# UNITED STATES PATENT AND TRADEMARK OFFICE

APPLICATION NO.	FILING DATE	FIRST NAMED INVENTOR	ATTORNEY DOCKET NO.	CONFIRMATION NO.
10/807,657	03/24/2004	Terrence K. Jones	A002 P00908-US1	3906
826	7590	01/05/2006	EXAMINER FERGUSON, MARISSA L	
ALSTON & BIRD LLP BANK OF AMERICA PLAZA 101 SOUTH TRYON STREET, SUITE 4000 CHARLOTTE, NC 28280-4000			ART UNIT 2854

**Office Action Summary**

## **DETAILED ACTION**

**FIG. 2**

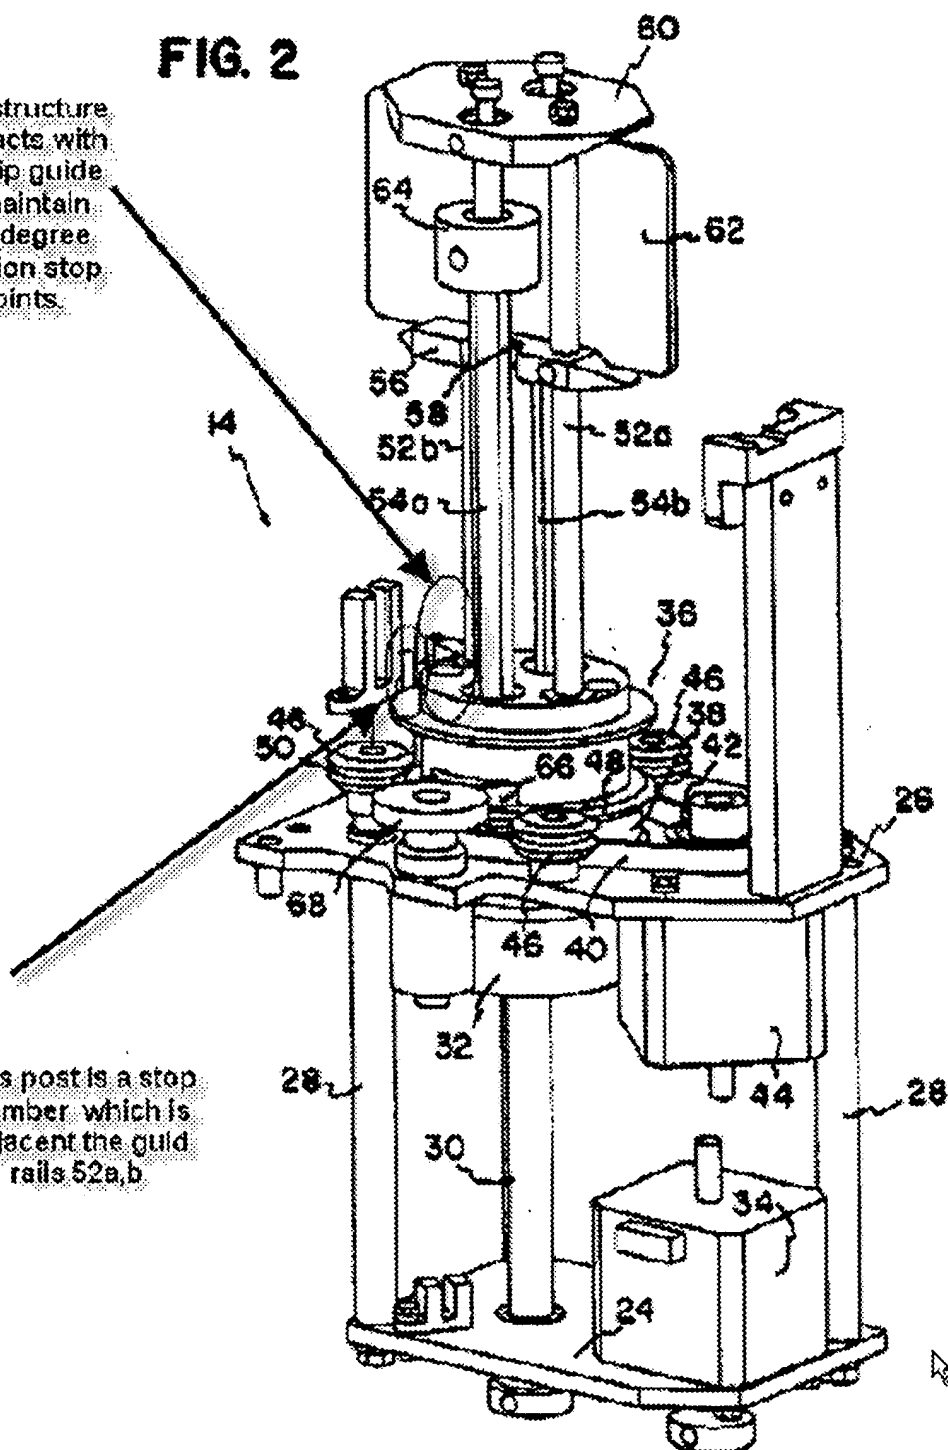
guide (56,60) coupled to the carrier unit for holding the media (62) and a flip stop member wherein when the carrier unit slides along the rail the flip stop member passively interacts with the rotatable flip guide to rotate thereby reorienting the media in the carrier unit (please refer to figure 2 on page 4).

The structure  
interacts with  
the flip guide  
to maintain  
180 degree  
rotation stop  
points.

This post is a stop  
member which is  
adjacent the guide  
rails 52a,b.

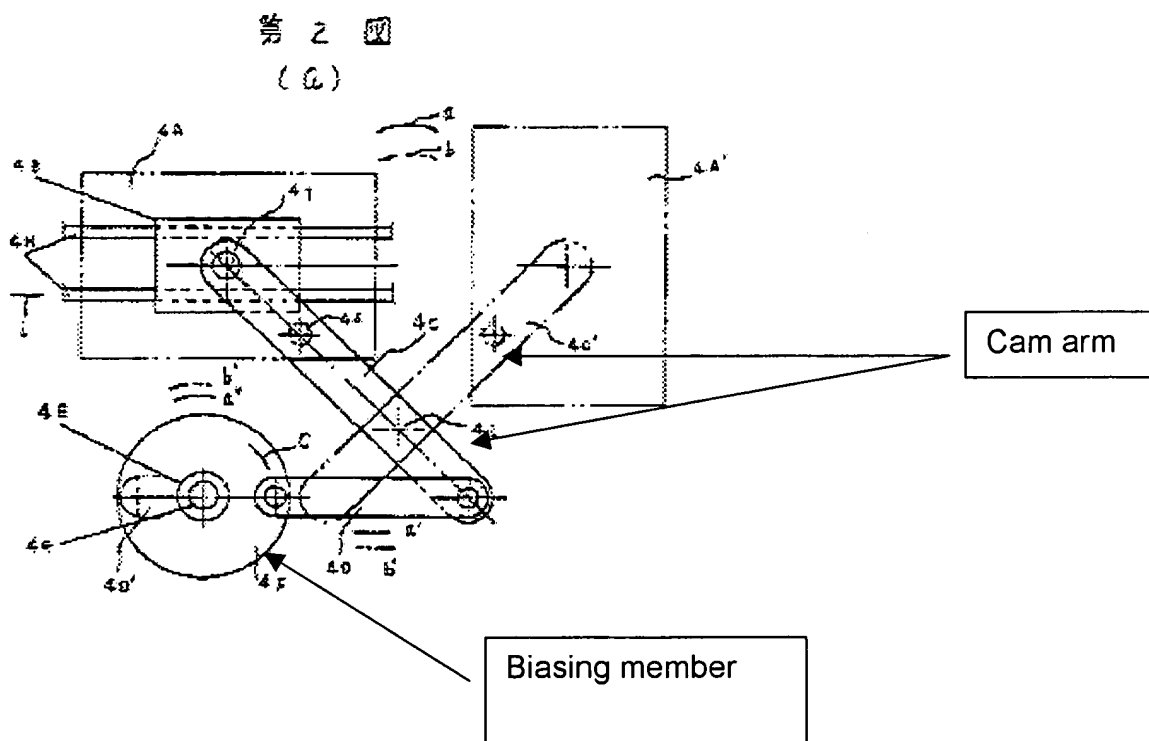
Regarding claims 11 and 27, Hiroyuki teaches a method and apparatus comprising a carrier unit (refer to figure c pasted in office action) comprising a cam arm (refer to figure 2a pasted in office action) coupled to a flip guide, wherein the carrier unit slides along a rail and a flip guide to rotate thereby reorient a media located in a carrier unit (refer to figure c pasted in office action). However, he does not explicitly disclose a stop member passively interacting with the flip guide. Skubic et al. teaches a stop member passively interacts with the rotatable flip guide to rotate thereby reorienting the media in the carrier unit (please refer to figure 2 on page 4).

Regarding claims 12 and 28, Hiroyuki teaches a method and apparatus for comprising a biasing member coupled to and exerting a force on a cam arm for assisting in rotation of the cam arm (please refer to figure 2a pasted in office action).

Regarding claims 13 and 29, Hiroyuki teaches a method and apparatus for comprising a biasing member coupled to and exerting a force on a rotatable flip guide for assisting in the rotation of the flip guide (please refer to figure 2a pasted in office action).

Regarding claims 15 and 31, Hiroyuki teaches a method and apparatus comprising a carrier unit comprising two flip guides (please refer to figure c pasted in office action) for holding the media.

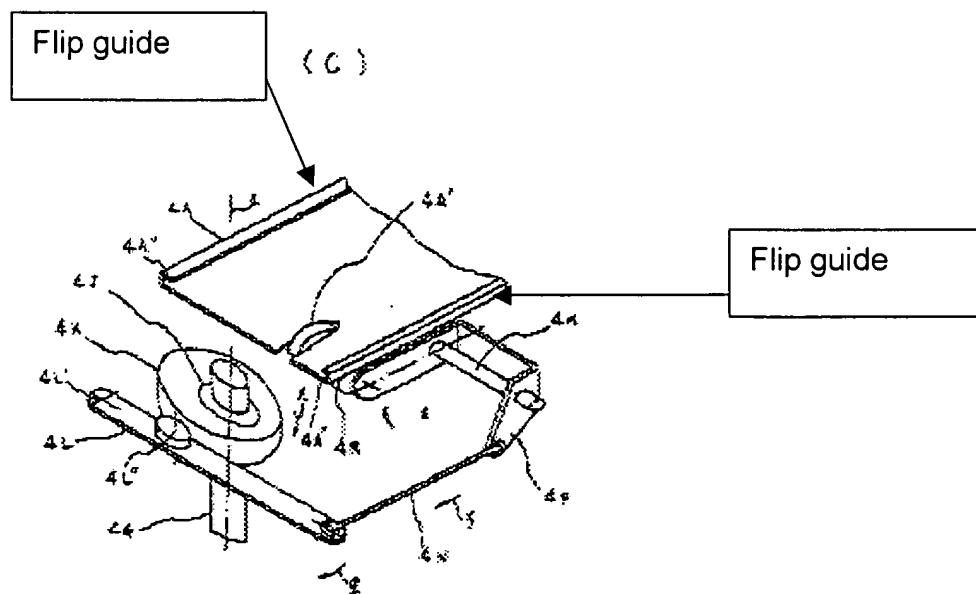
Regarding claims 10 and 26, Hiroyuki teaches a method and apparatus comprising a frame comprising at least one guide rail (4H) extending relative to a defined media path of a printer, a carrier unit consisting of flip guide members (please refer to figure c pasted in office action) slidably coupled to the guide rail for transporting the media in a first direction and in an opposite direction along a guide rail (Figure on abstract) and at least one rotatable flip guide (please refer to figure c pasted in office action) coupled to the carrier unit for holding the media (Purpose and constitution). However, he does not explicitly disclose a flip stop member wherein when the carrier unit slides along the rail the flip stop member passively interacts (note: the examiner does not understand how the invention can work without some type of driven means) with the rotatable flip guide to rotate thereby reorienting the media in the carrier unit. at least one rotatable flip guide (56,60) coupled to the carrier unit for holding the media (62) and a flip stop member wherein when the carrier unit slides along the rail the flip stop member passively interacts with the

Regarding claim 41, a method and apparatus comprising a frame comprising at least one guide rail (4H) extending relative to a defined media path of a printer, a carrier unit consisting of flip guide members (please refer to figure c pasted in office action) slidably coupled to the guide rail for transporting the media in a first direction and in an opposite direction along a guide rail (Figure on abstract), at least one rotatable flip guide (please refer to figure c pasted in office action) coupled to the carrier unit for holding the media (Purpose and constitution) and a cam arm (refer to figure 2a pasted in office action) coupled to a flip guide, wherein the carrier unit slides along a rail and a flip guide to rotate thereby reorient a media located in a carrier unit (refer to figure c pasted in office action). However, he does not explicitly disclose a stop member passively interacting with the flip guide. Skubic et al. teaches a stop member passively
